SECTION 73
SUPPLEMENTARY DESIGN REPORT

SEPTEMBER 2021

This report is intended to illustrate the differences between the consented development scheme and the latest proposed design iteration. The proposed design incorporates changes concerning the refinement and evolution of the consented design in response to concerns of environmental, practical, and cultural changes that have occurred through the course of the project.

Proposed Level 05 Plan

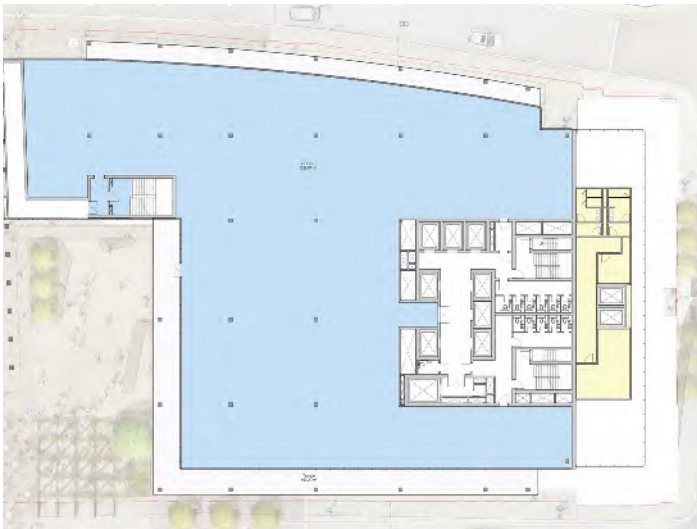
Additional office space has replaced the Consented Scheme's restaurant, located above the former Police Headquarters. The same external envelope has been retained.

Proposed Level 06 Plan

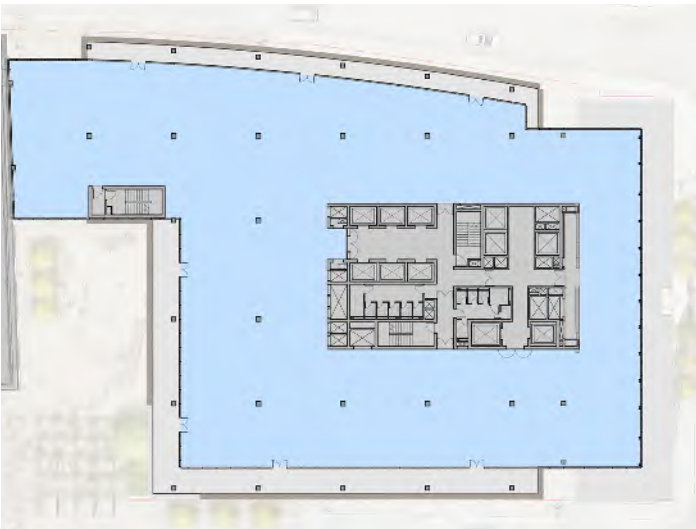
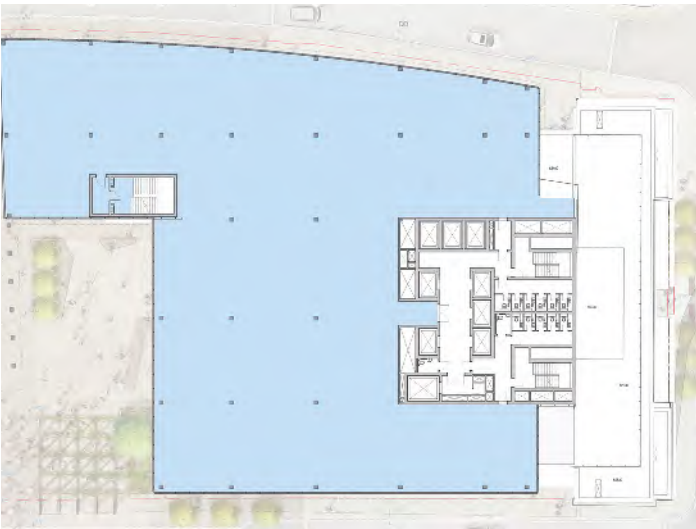
At Level 06 a terrace is provided to the North, South, and West elevations of the office area, as introduced in the Consented scheme. Similar to Level 05, the office occupies the envelope above the former Police Headquarters, which was formerly proposed as a restaurant.

Proposed Level 07 Plan

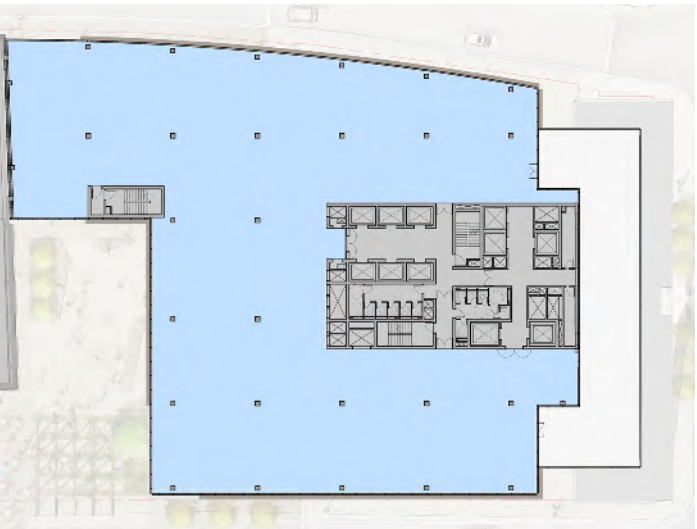
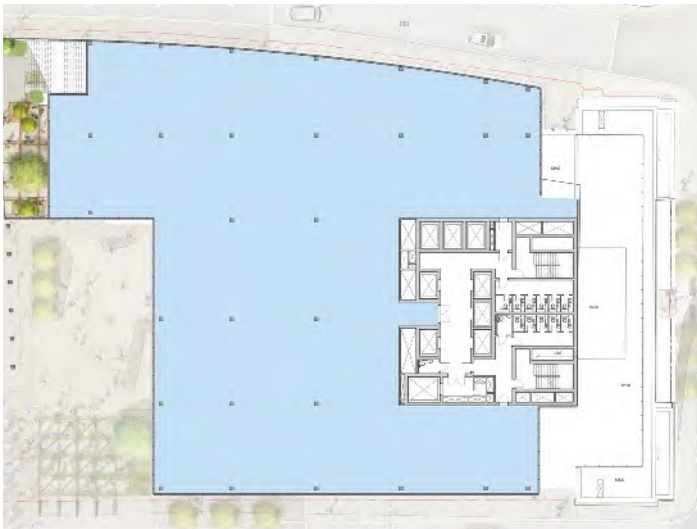
The occupiable extent of the terrace has increased significantly, facilitating demand for increased access to outdoor space from office spaces. The integration of the former Police Headquarters into the Office block allowed for the consolidation of mechanical plant rooms, freeing up the large terrace.

Proposed Level 08 Plan

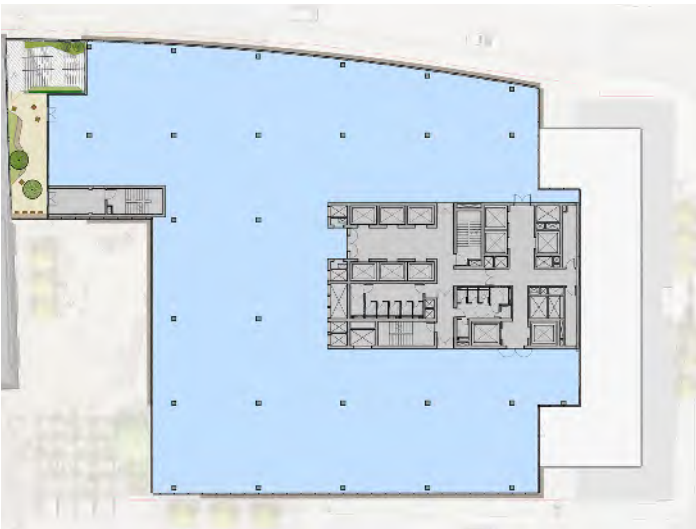
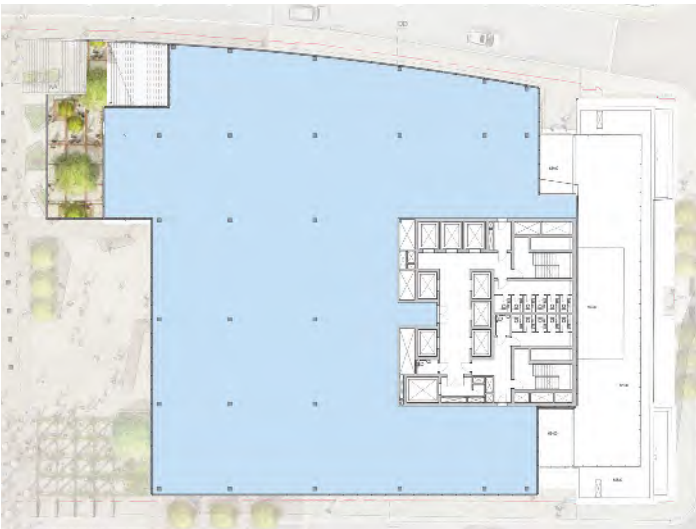
The third escape stair has been brought up to Level 08 to allow an additional emergency exit from the publicly accessible terrace on Level 10. This allows the office block to operate independently due to phasing and operational flexibility.

Proposed Level 10 Roof Terrace

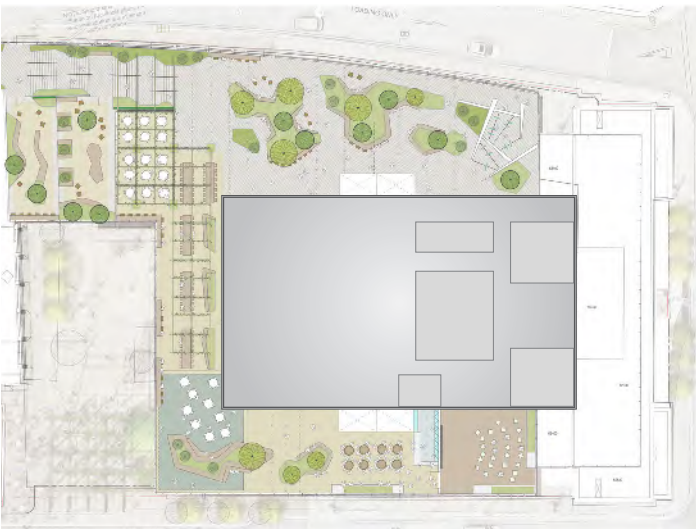
The publicly accessible Roof Terrace has been reconfigured to better provide a variety of spaces and uses in accordance with the proposed core configuration, as well as additional area in the plant deck above. Part of the space under the plant deck has been enclosed to ensure usage during all seasons, increasing its function as a publicly accessible space. The remaining area under the plant deck serves as covered terrace space, further supporting all-weather use.

To ensure safety for anyone visiting the roof terrace, as well as members of the public on the streets below, the balustrade around the terrace has been increased to 3m in height.

Proposed Level Plant Deck

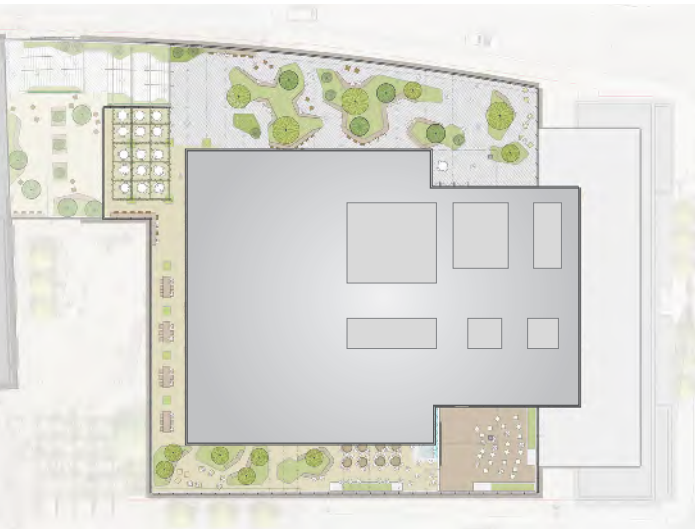
The Proposed Plant Deck includes increased space for mechanical equipment that is needed to provide for increased air exchange rates, as required in post-pandemic office buildings. In addition to this, high-performing sustainability criteria has been targeted to bring the project forward in a more socially responsible way. This also had a considerable impact on the size of equipment required on the Plant Deck.

Louvre screens are to be provided at the perimeter of the Plant Deck to mask the equipment both visually and acoustically.

Proposed Scheme

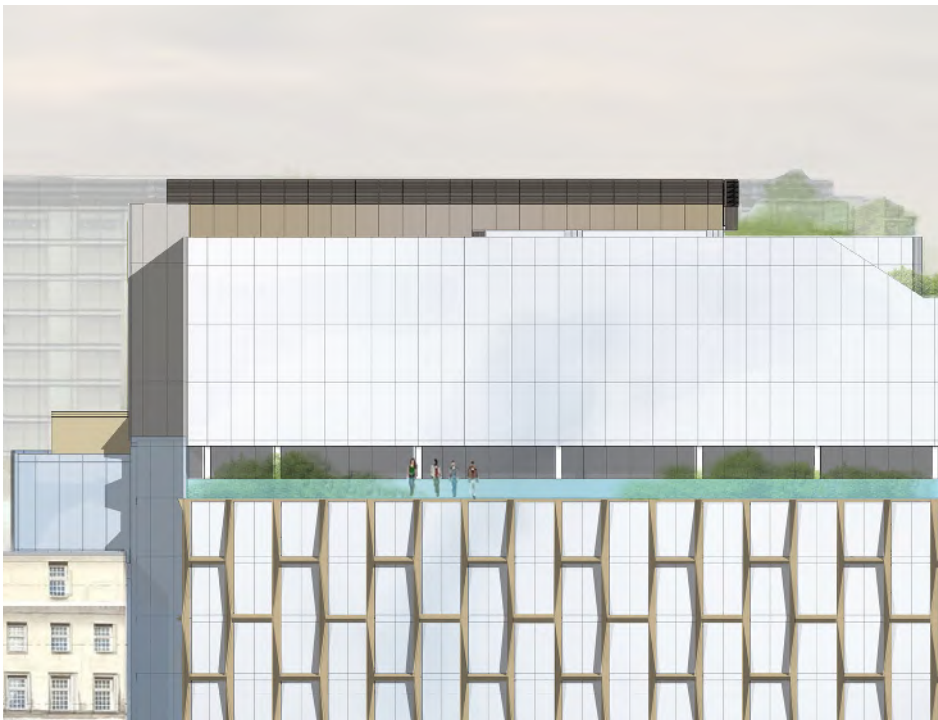
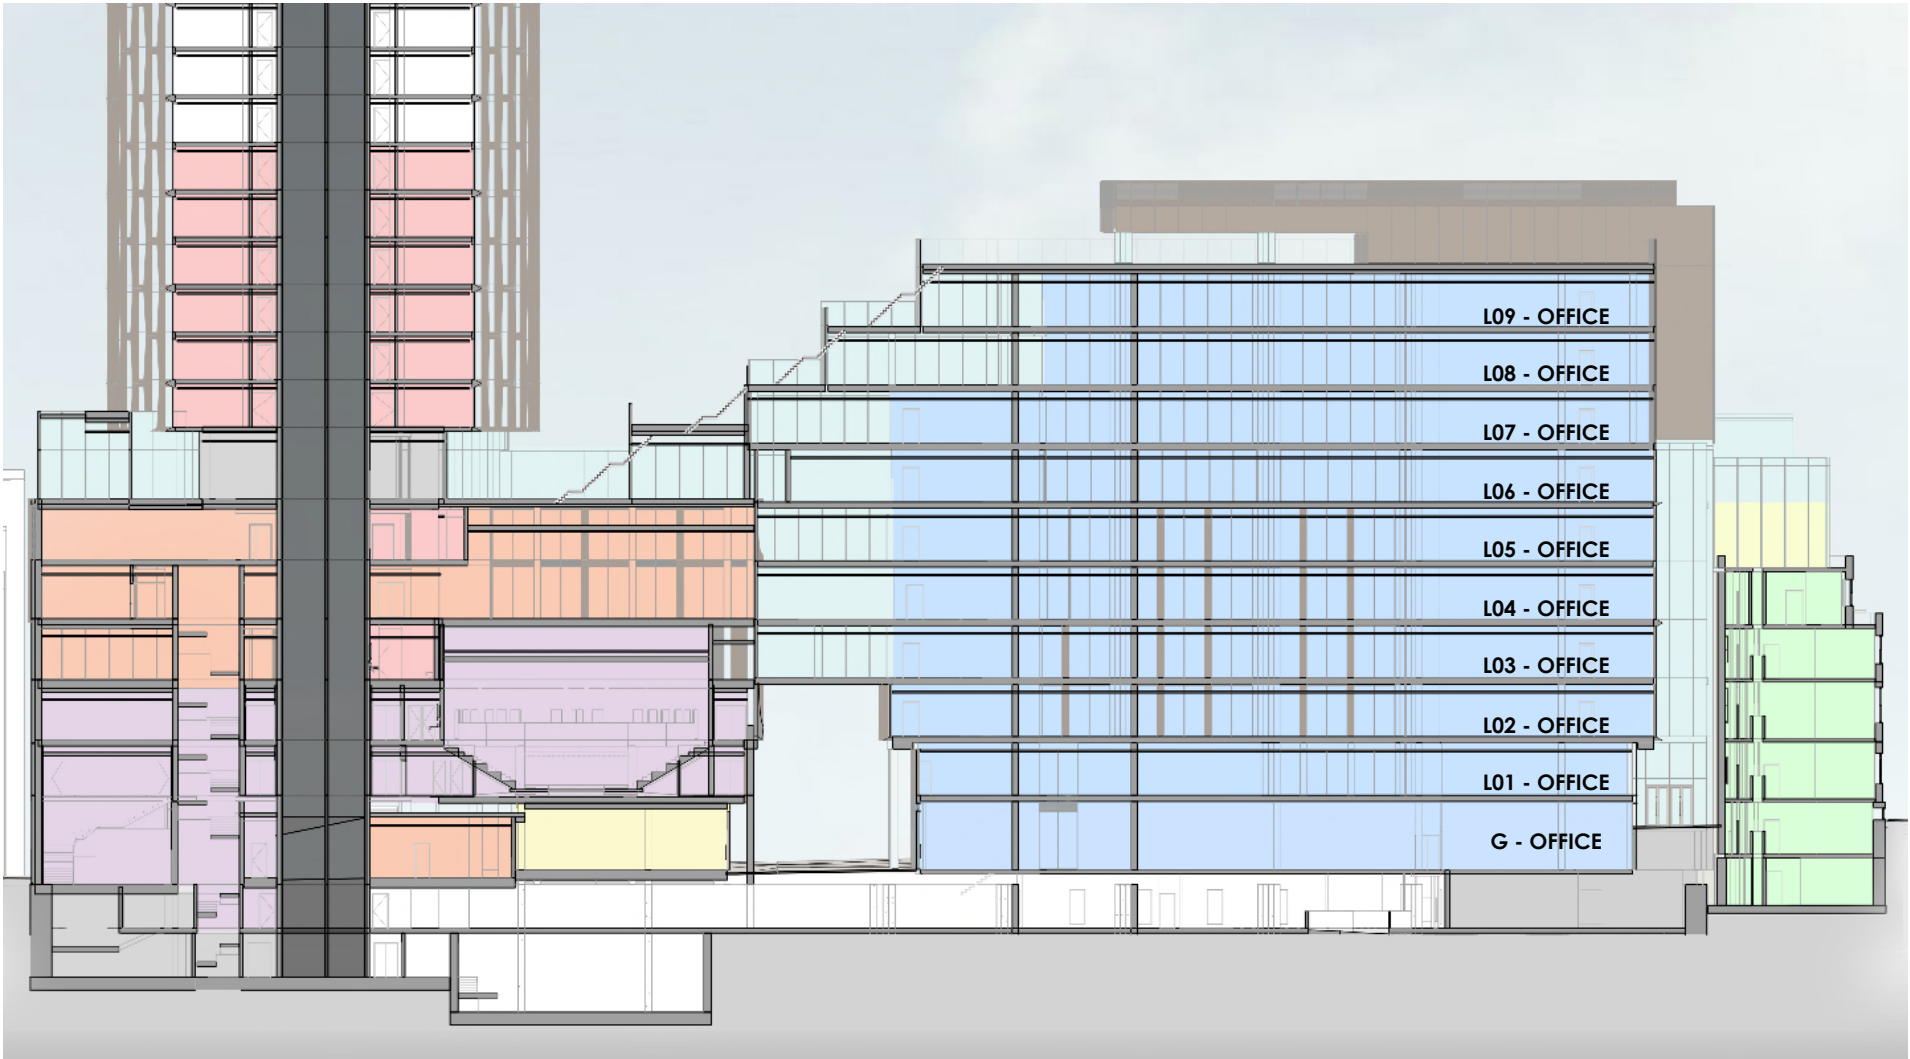
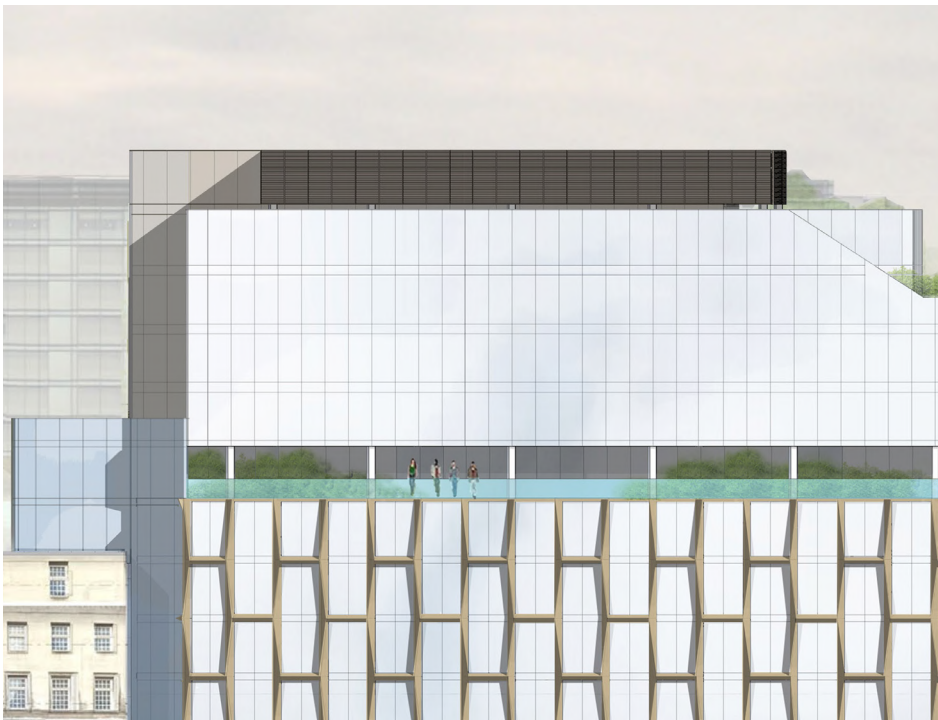
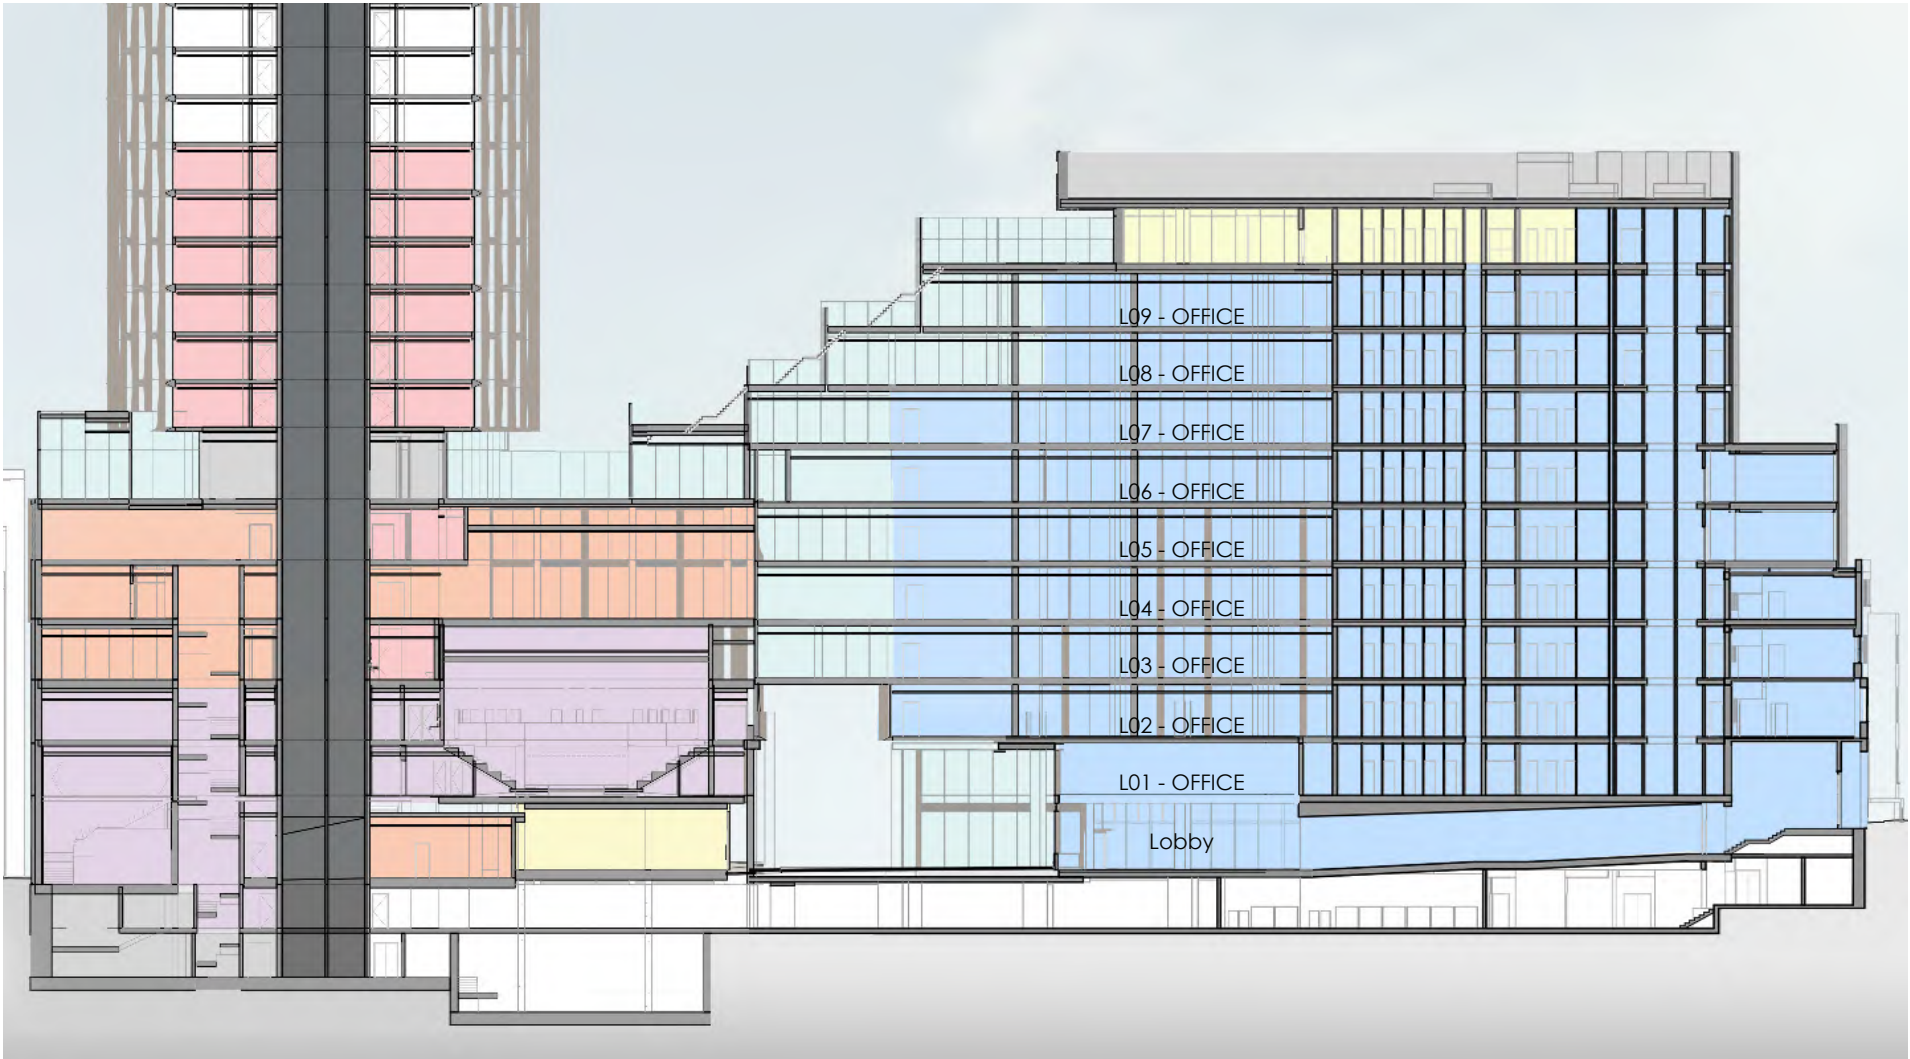
Through incorporating the former Police Headquarters into the offices, the mechanical plant space was consolidated with the enlarged plant deck above the Level 10 terrace of the Office Block. Below this plant deck, a portion of the covered space has been enclosed to provide space for a restaurant, taking place of the restaurant from the Level 05&06 of the Boutique Hotel. To provide adequate clear height for the restaurant, the plant deck has been slightly raised. For safety, the height of the terrace balustrade has been increased to 3m.
